Perry Nuclear Power Plant
Docket No. 50-440
Responses on Offsite Dose
Calculation Manual, Rev. 2

RESPONSE TO NRC REVIEW COMMENTS ON THE
PNPP OFFSITE DOSE CALCULATION MANUAL

FIGURE 3.0-1
VENT SYSTEM FLOW DIAGRAM

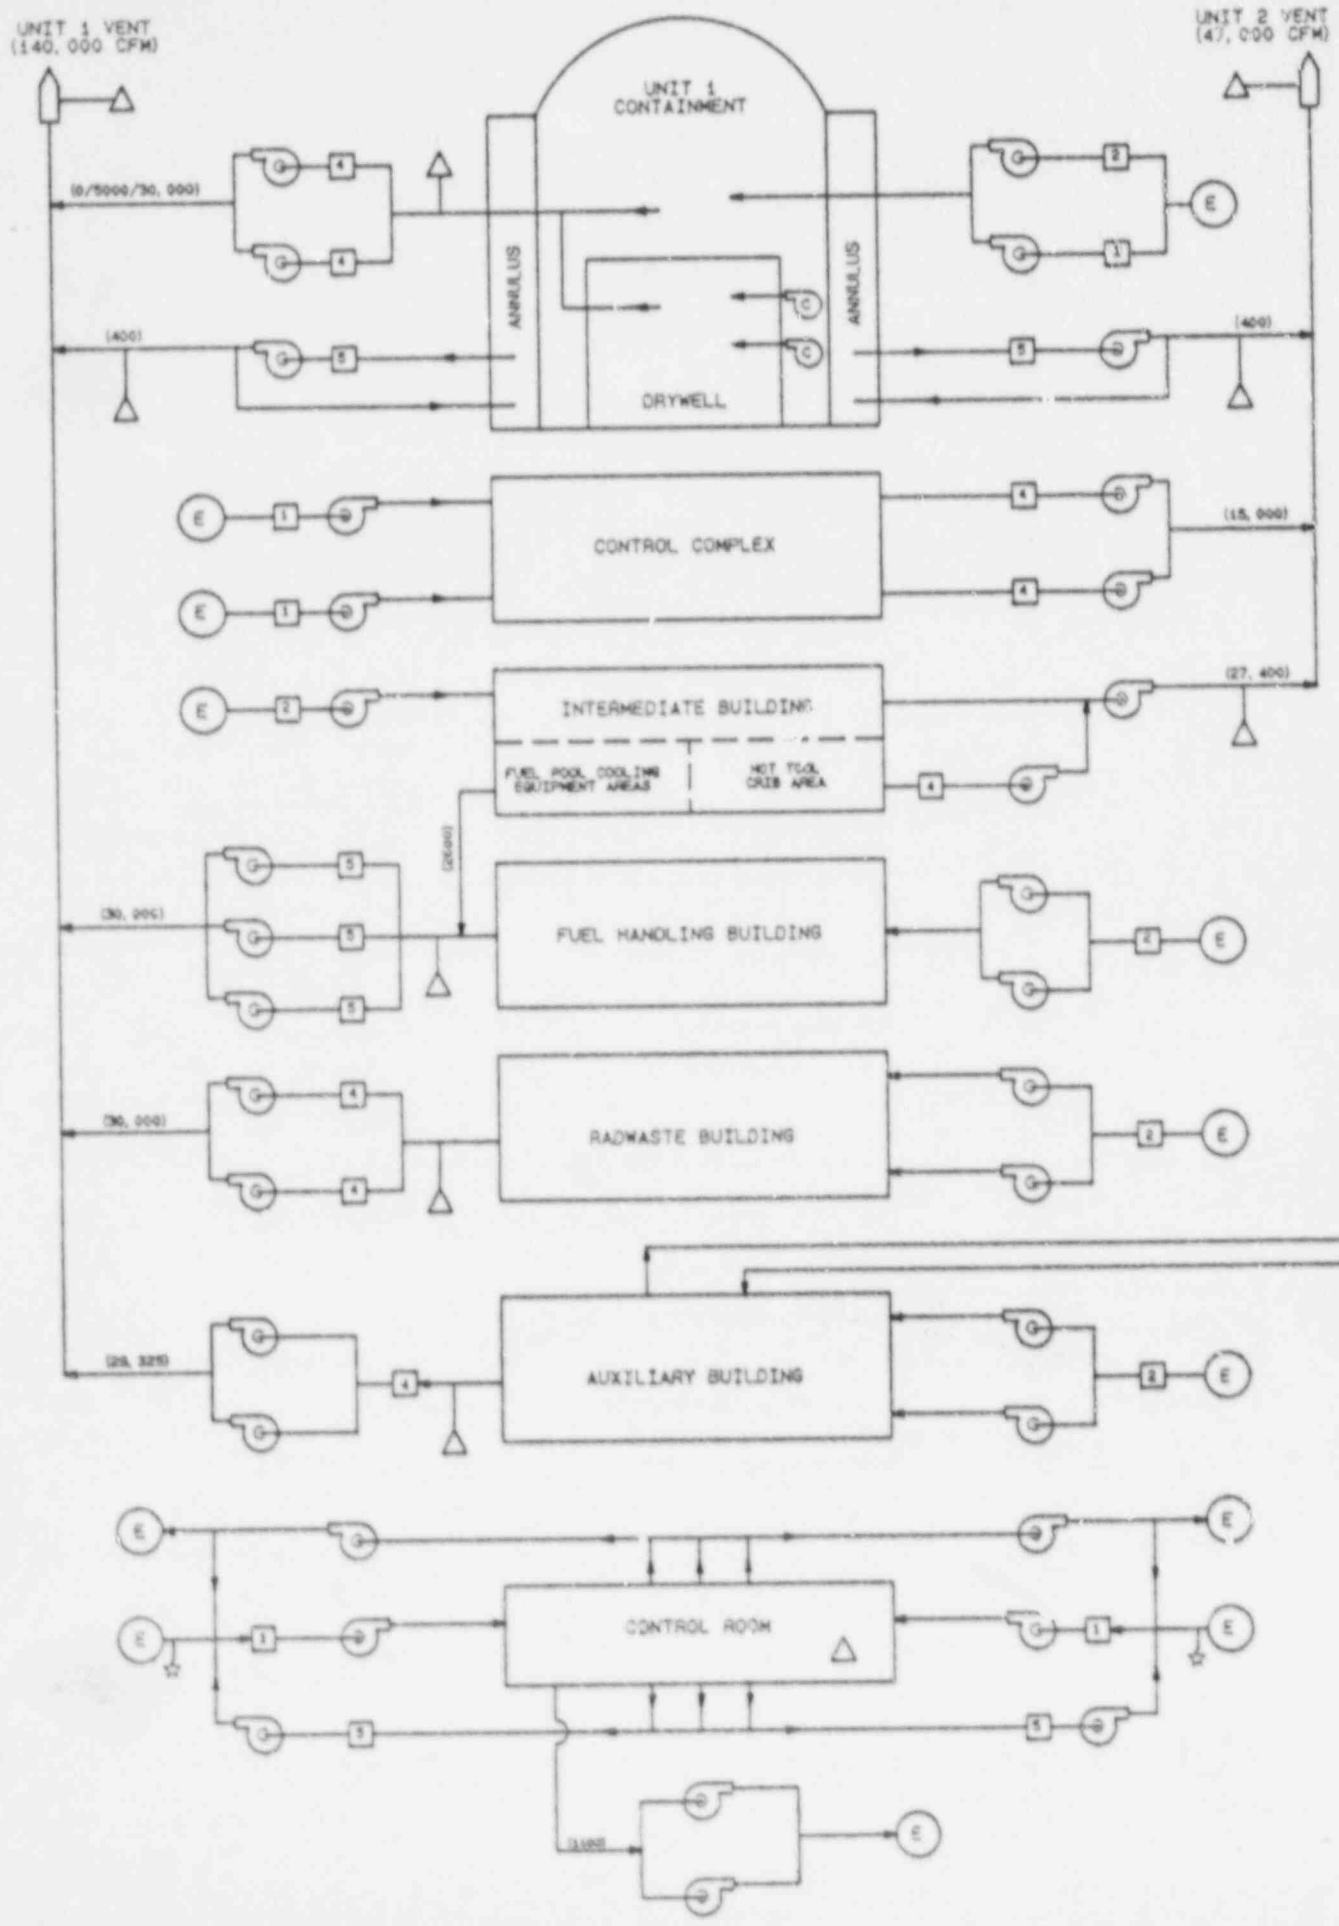
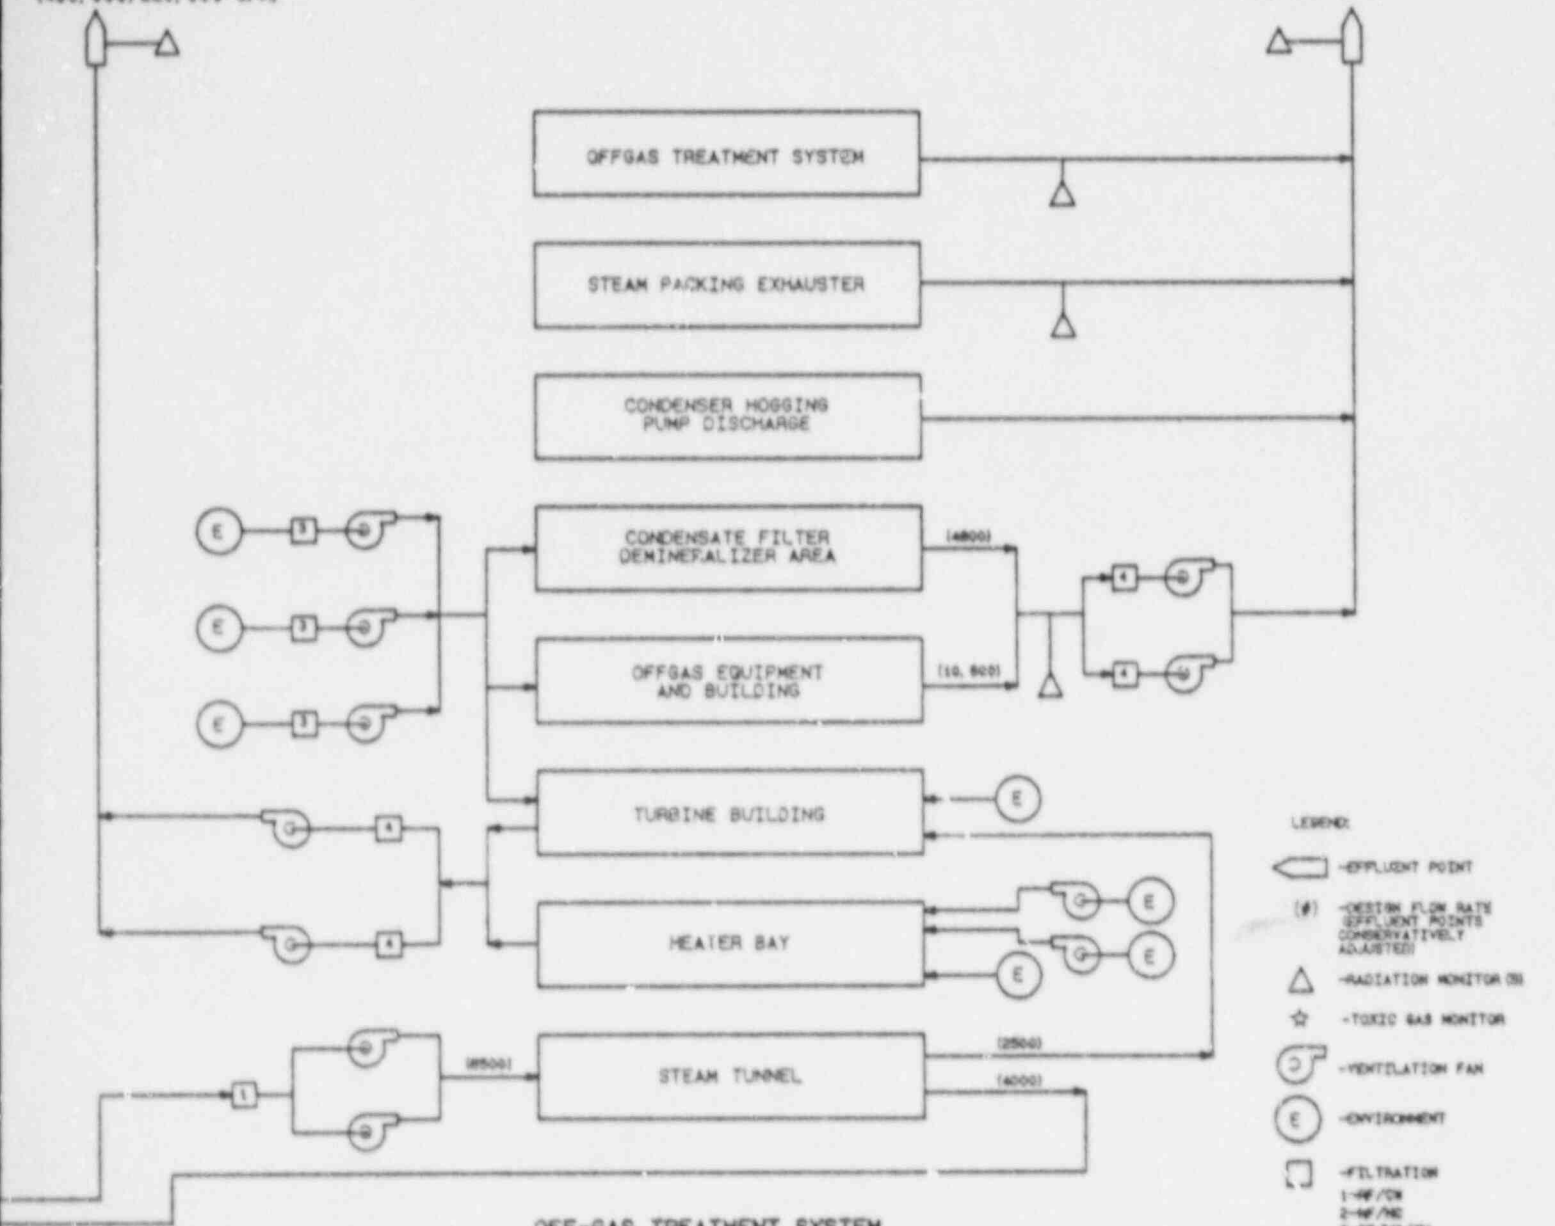
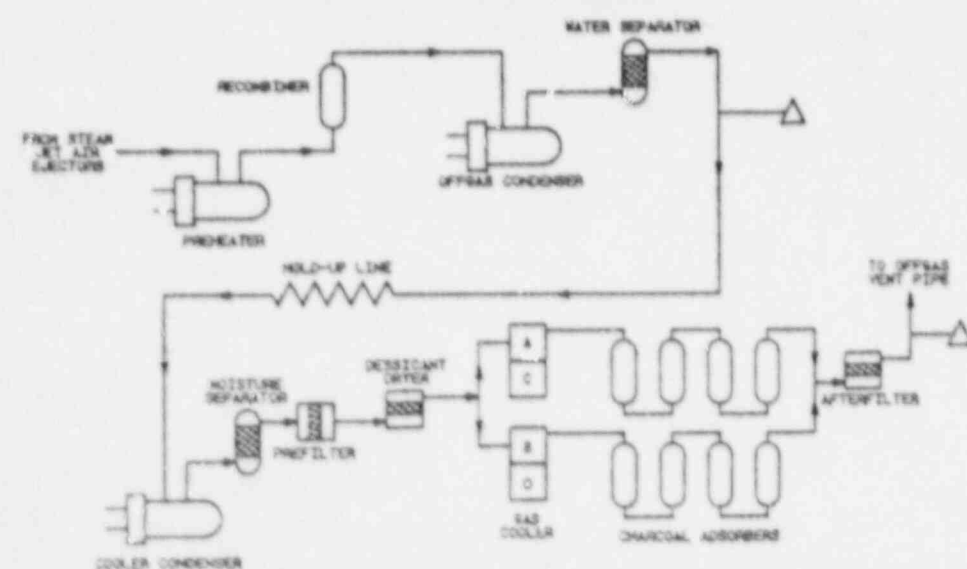
1. Figure 3.0-1 (probably page 29) showing the gaseous effluent release points is missing from the ODCM.

7. A simplified diagram illustrating the discharge pathways for the radioactive gaseous waste systems is not included in the ODCM.

Response: As noted in the NRC cover letter forwarding this TER, Figure 3.0-1 was found by the NRC and was reviewed. The NRC requested that this complex figure be replaced with a simplified block diagram. This figure has therefore been redrafted, for inclusion in the ODCM, to improve clarity. This redrafted figure is enclosed for your information as Attachment 2 to this letter.

Response: See response to Additional Discrepancy 1.
